CONSTRUCTION PLANS FOR: WATER PUMP STATION AND WATER MAINS

ARAPAHO ROAD PHASE III
 PLAN & PROFILE
 STORM SEWER 'B' STA. 0+85.21 TO STA. 5+00

TOWN OF ADDISON

ARAPAHO ROAD PHASE III
PLAN & PROFILE
STORM SEWER 'B' STA. 5+00 TO STA. 10+00

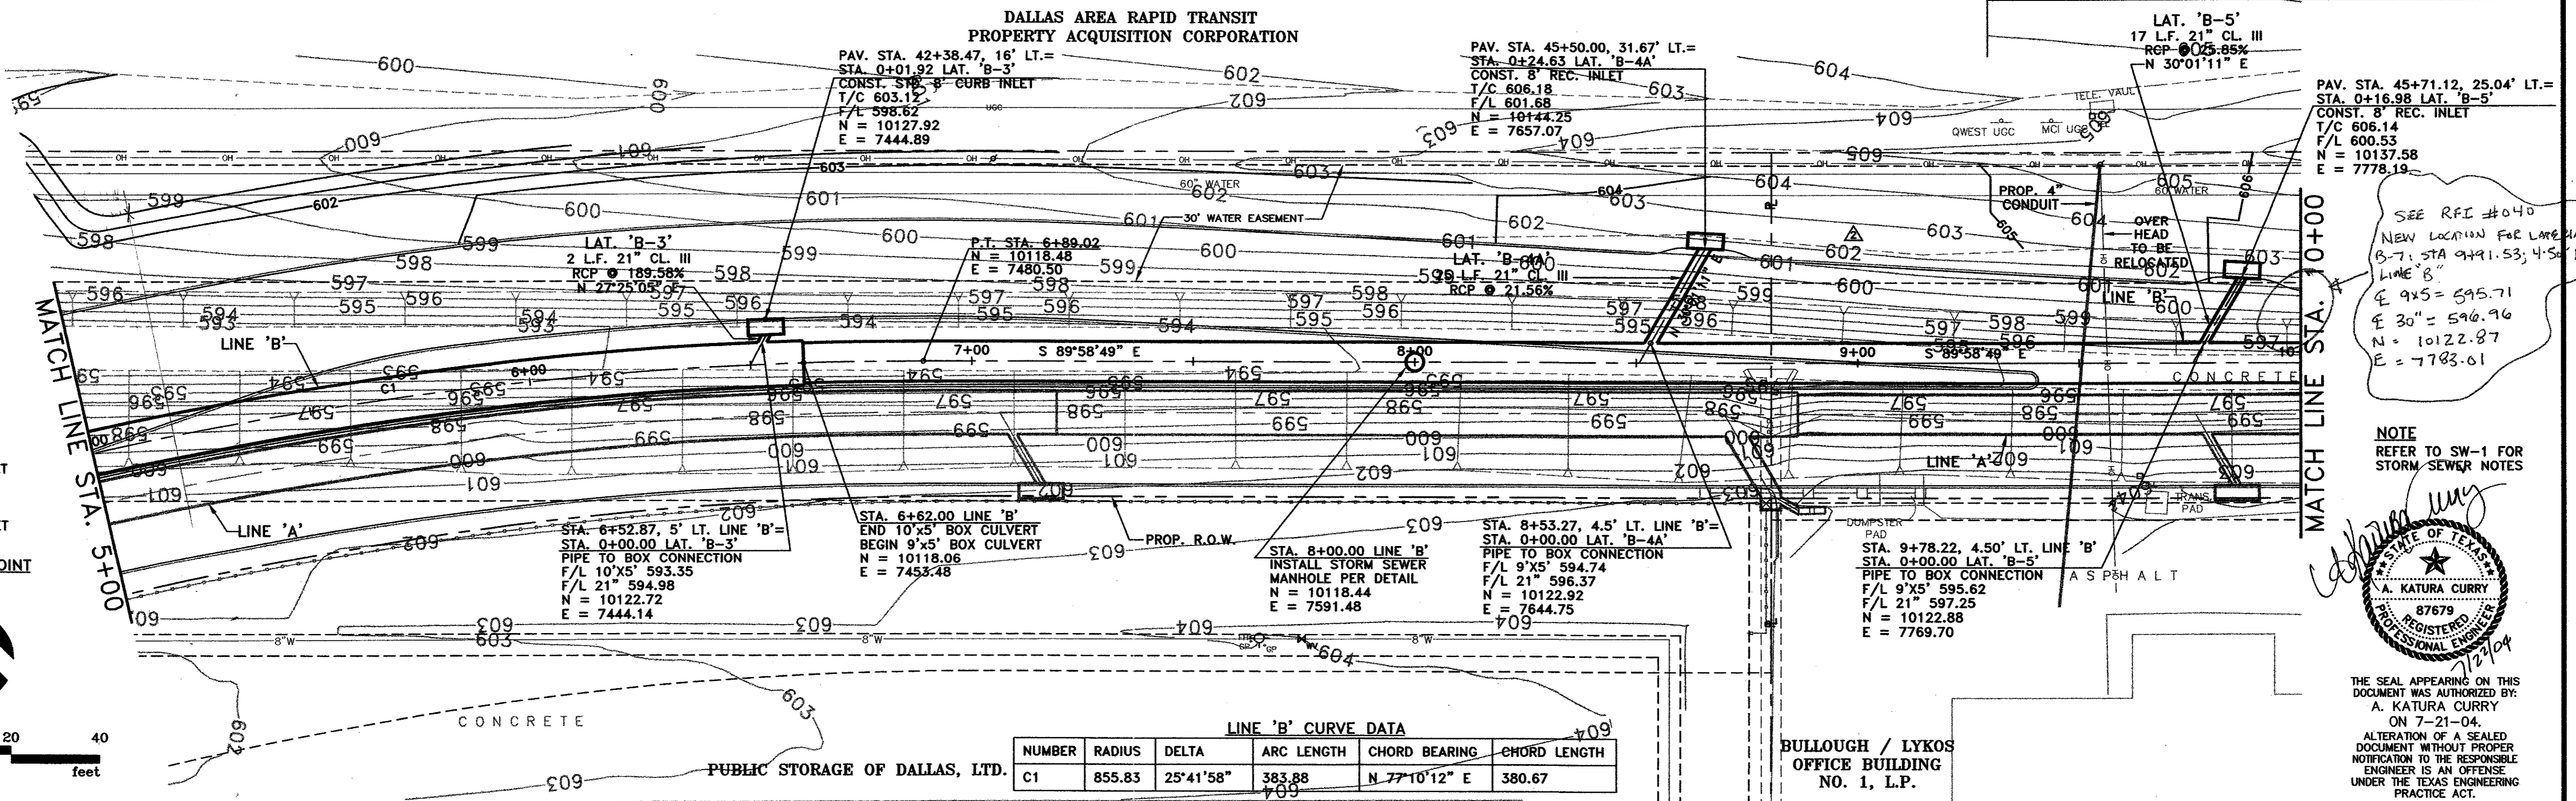
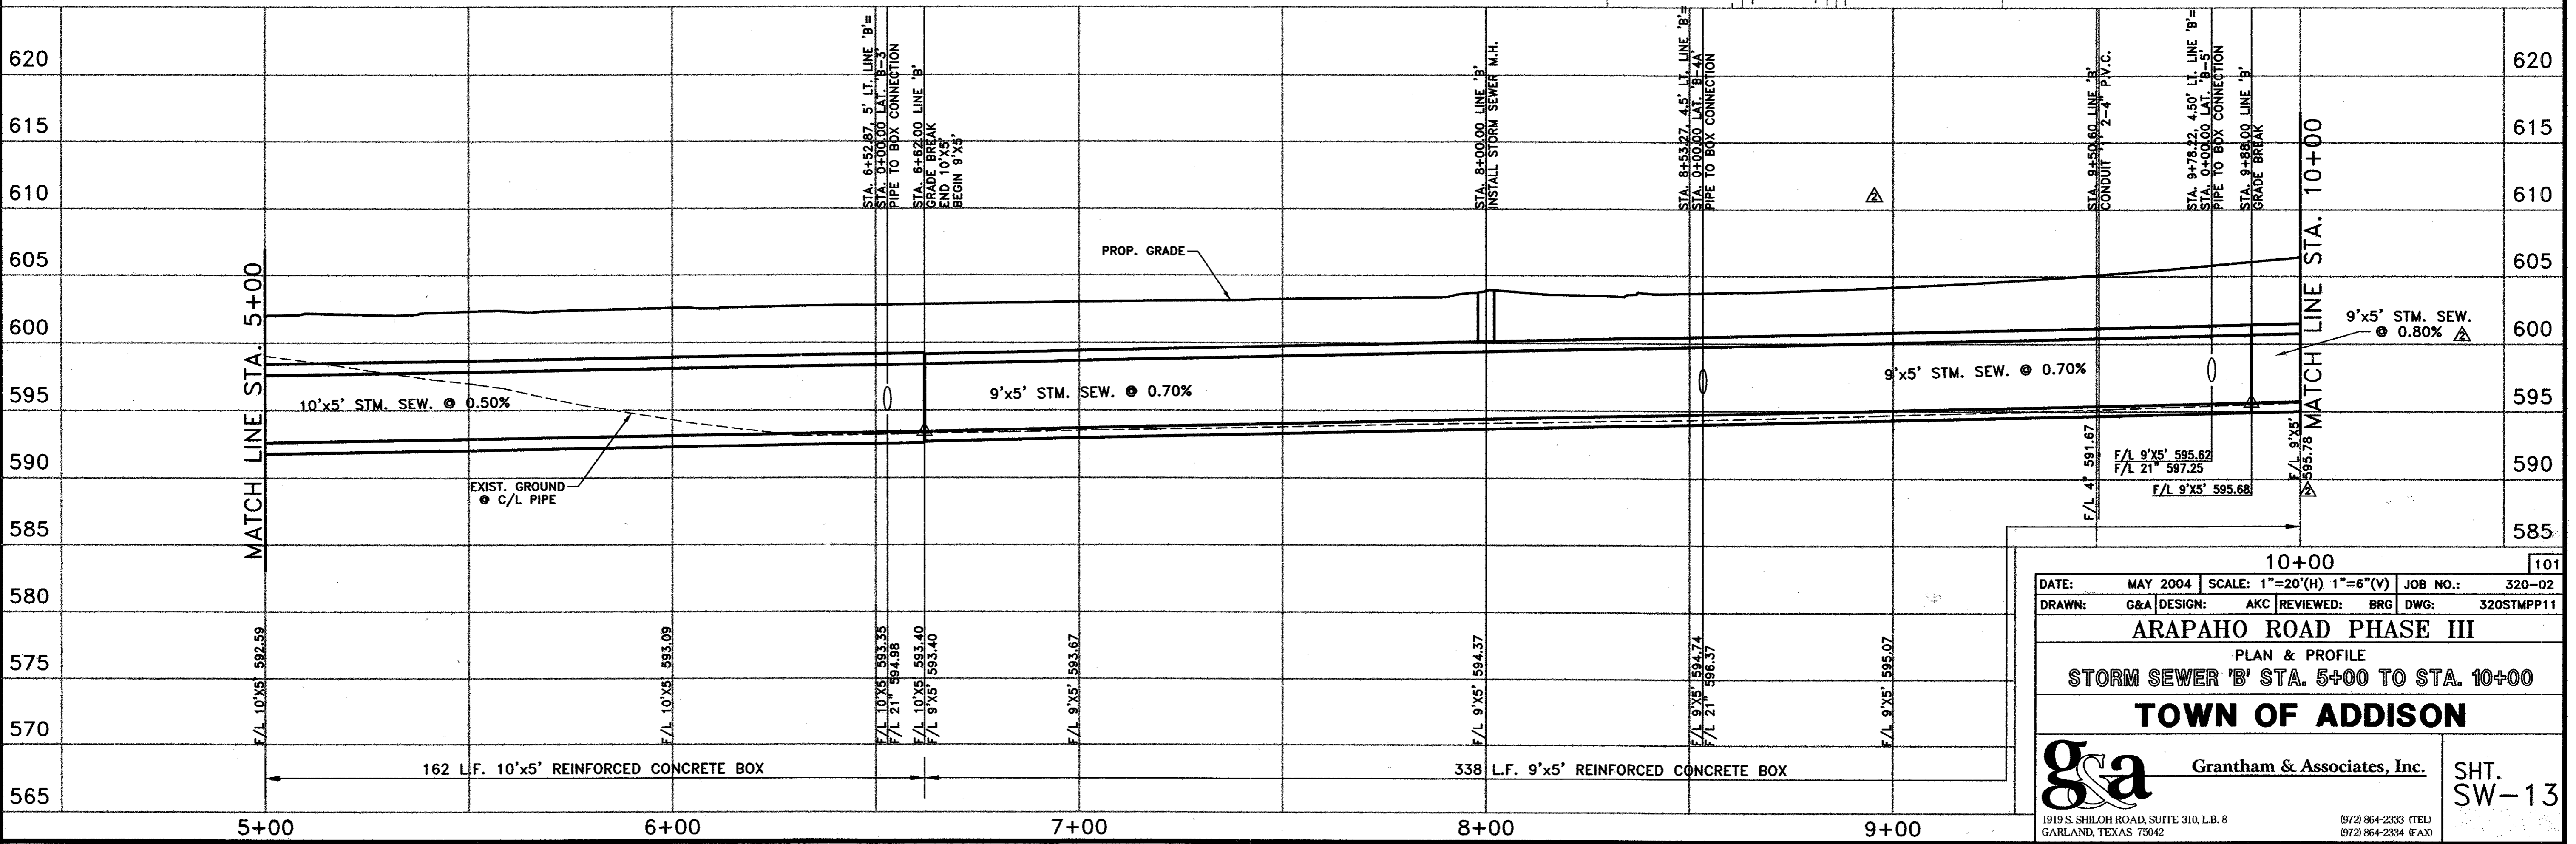
SEE RFI #040
NEW LOCATION FOR LANE 24 L
B-7. STA 9+91.53; 4.50' LT.
LINE 'B'
E 9'x5' = 595.71
E 30" = 596.96
N = 10122.87
E = 7783.01

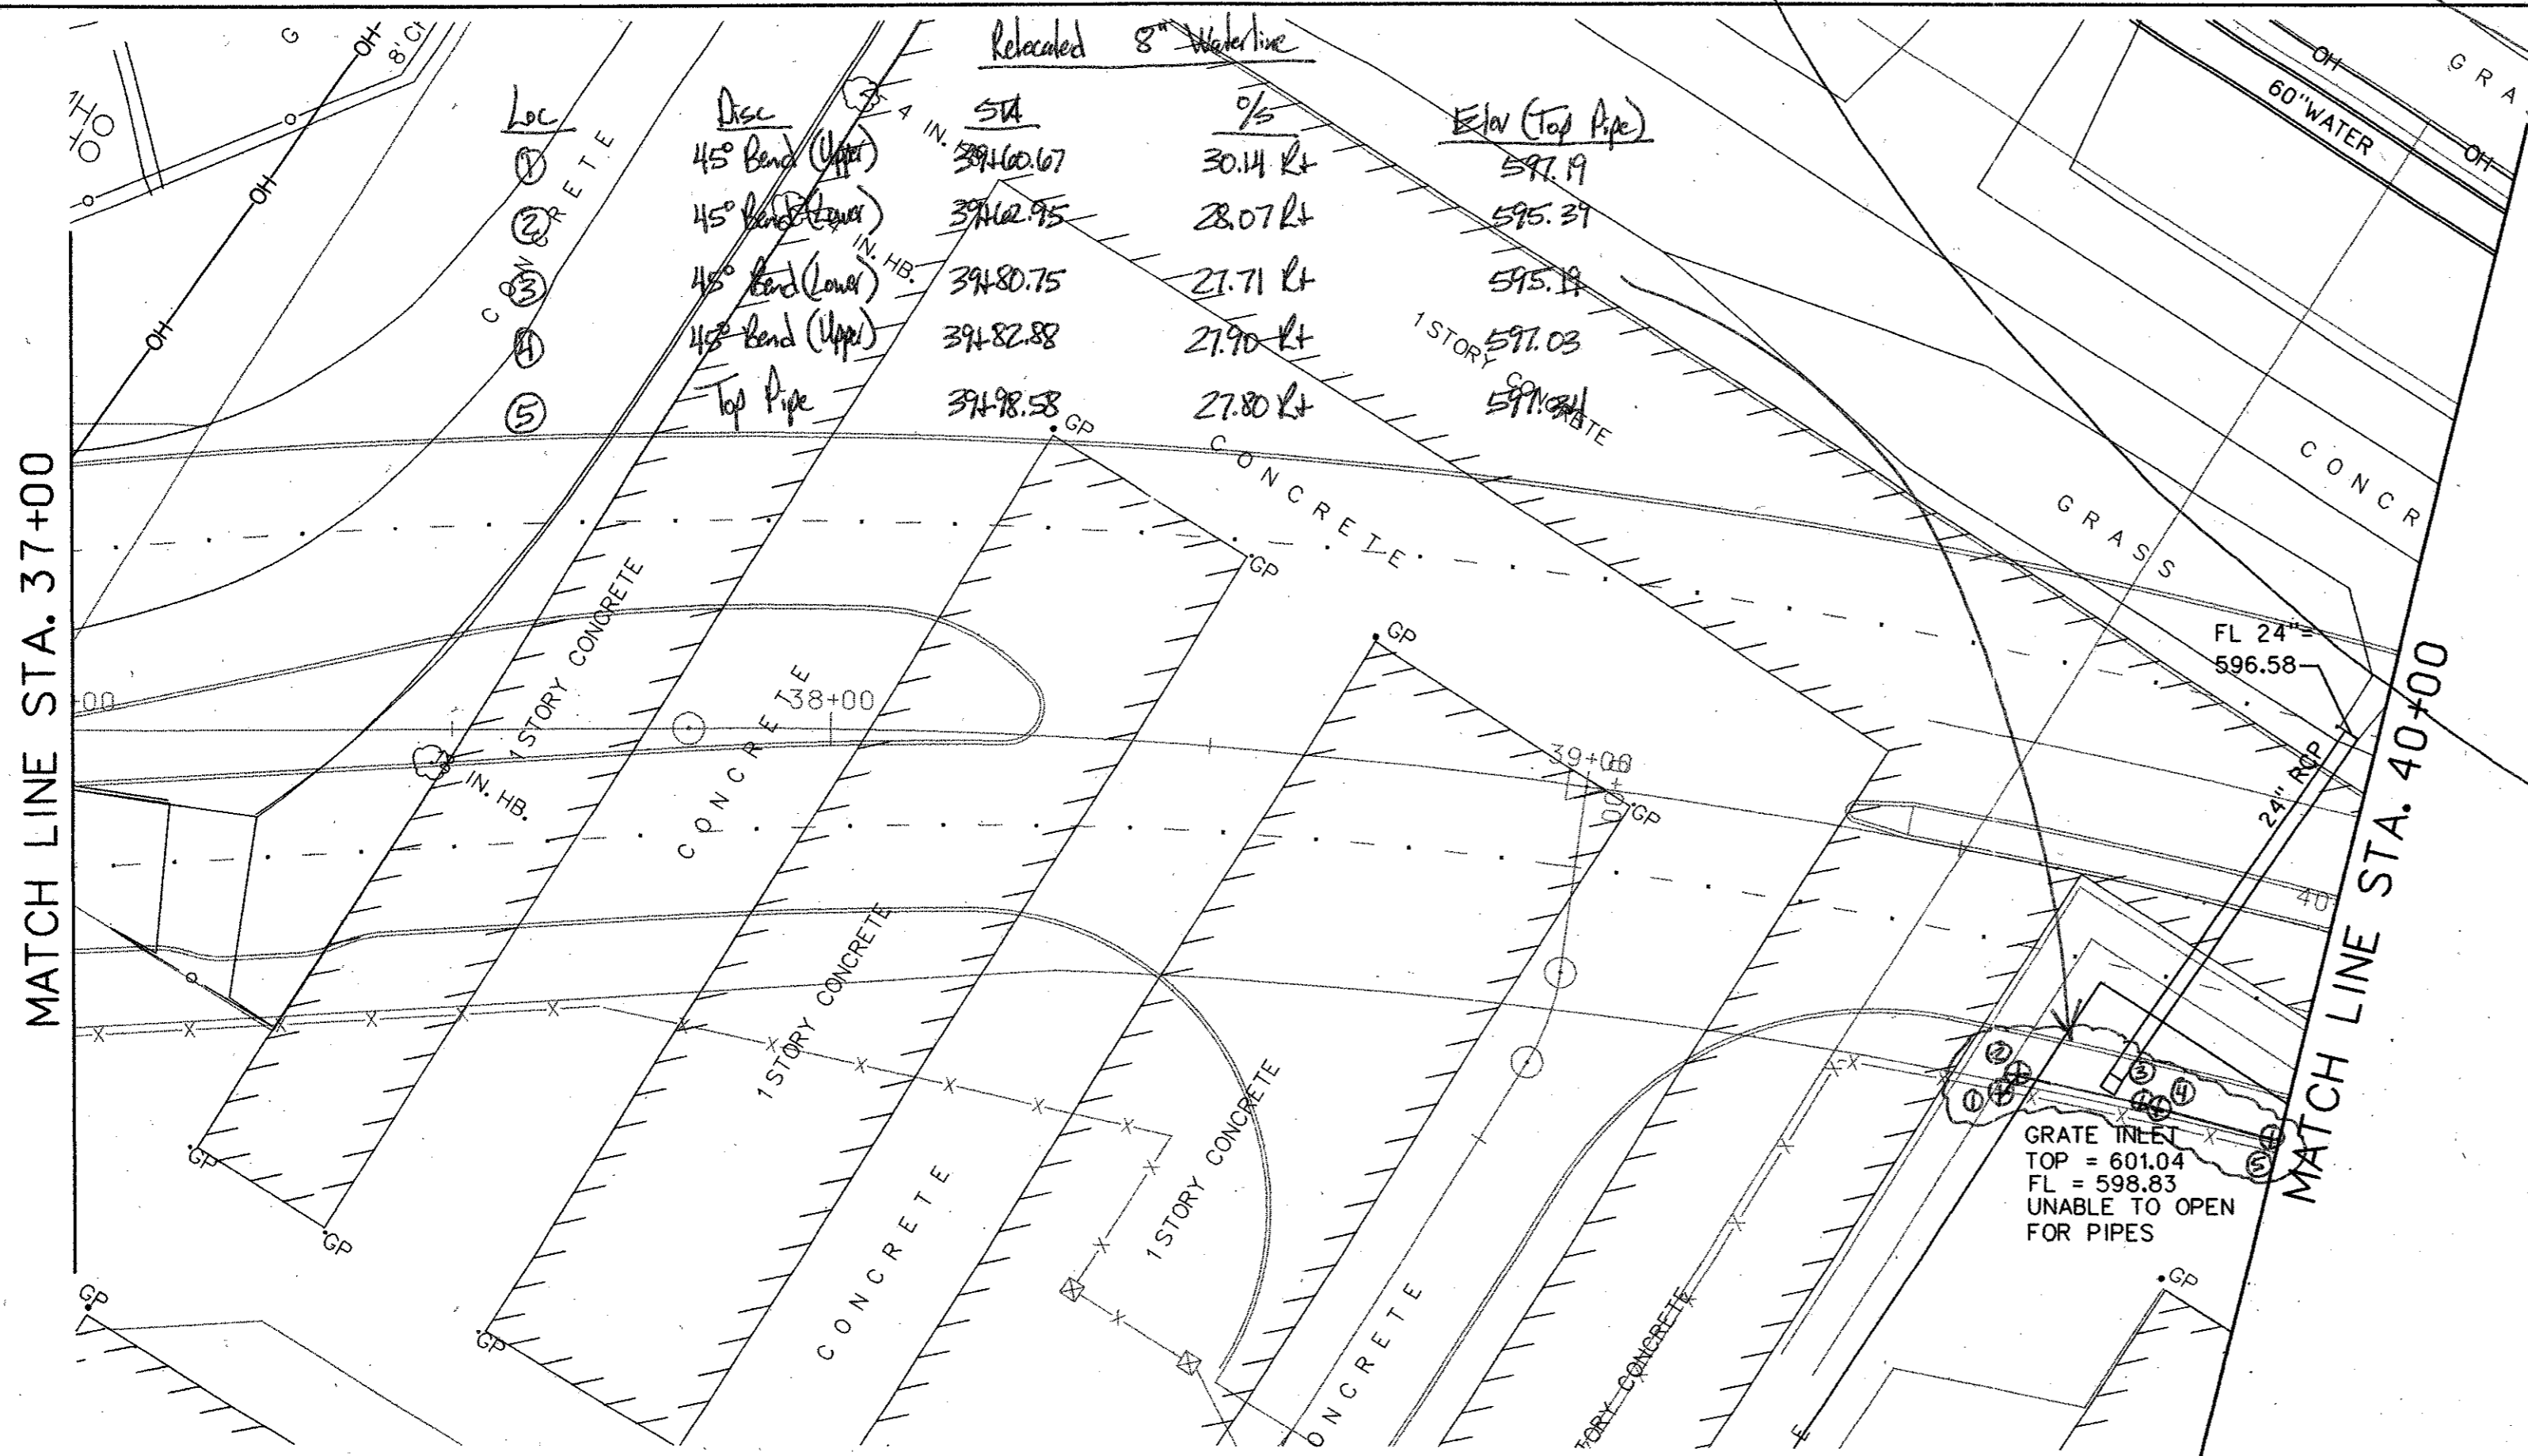
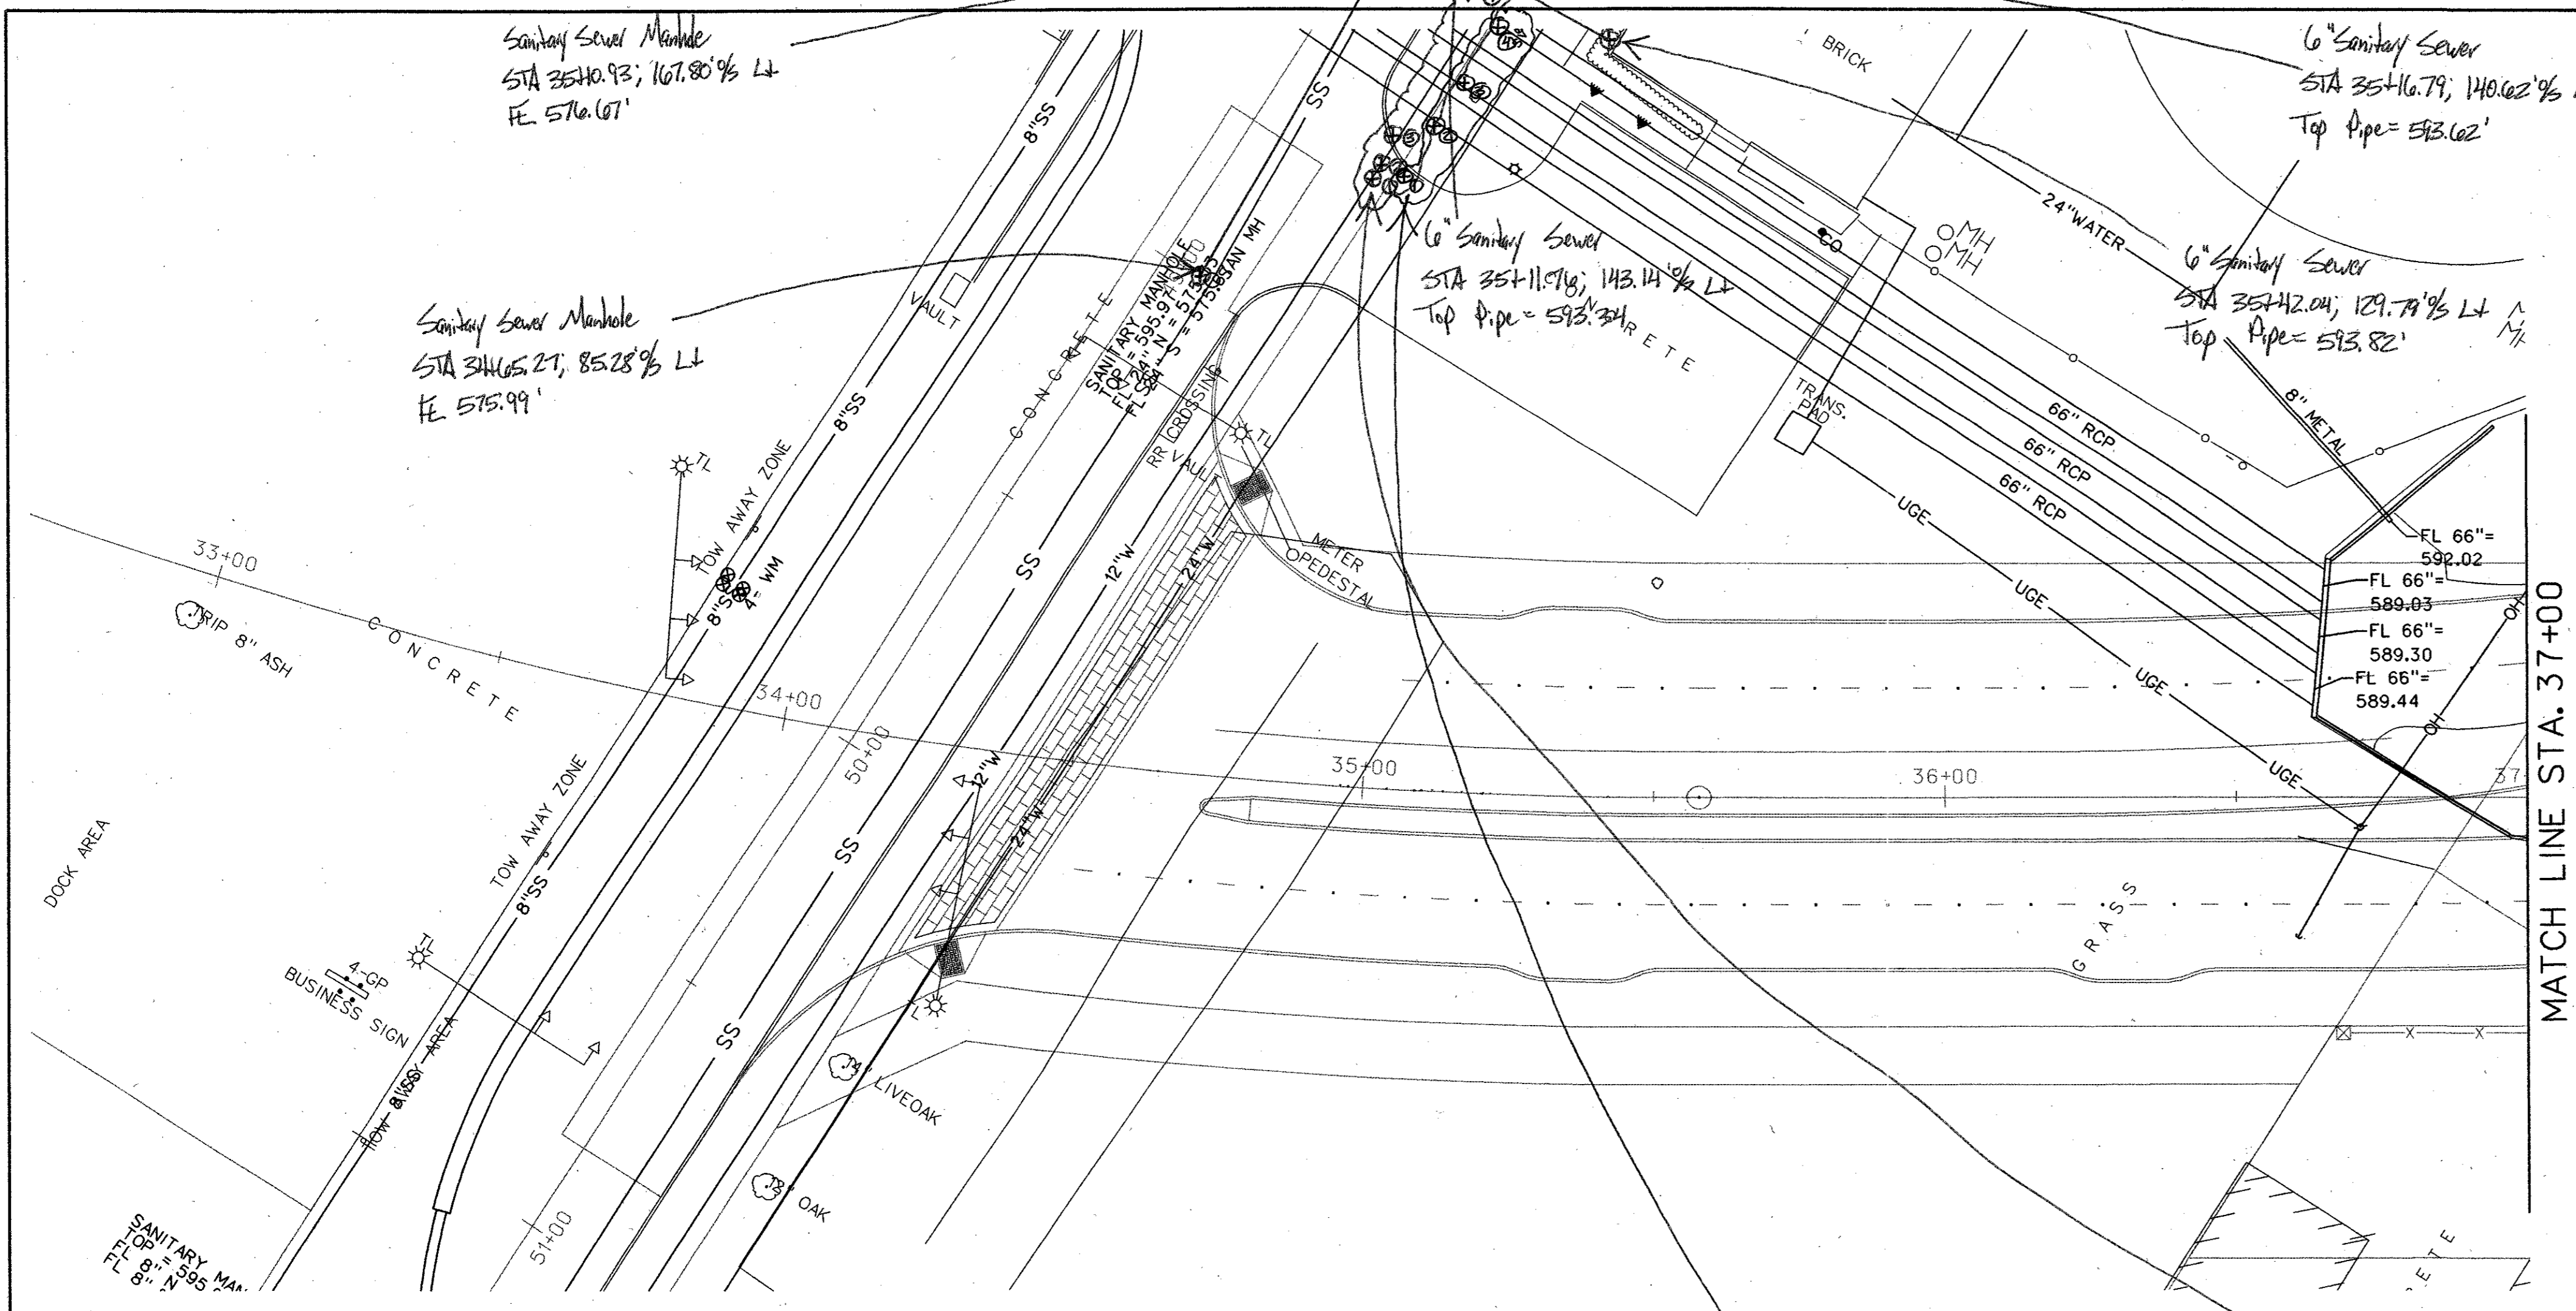
12" Waterline Lowering			
Loc	Desc	STA	%
①	Valve Stem	34+95.68	104.30 LT
②	Upper 45° Bend	34+97.47	106.99 LT
③	Lower 45° Bend	35+00.42	112.02 LT
④	Lower 45° Bend	35+17.59	138.52 LT
⑤	Upper 45° Bend	35+21.77	144.43 LT
⑥	Valve Stem	35+21.05	147.70 LT

24" Waterline			
Loc	Desc	STA	%
①	Top Pipe	35+08.99	106.26 LT
②	↑	35+08.91	113.94 LT
③	↓	35+13.75	121.88 LT
④	Top Pipe	35+20.56	132.35 LT
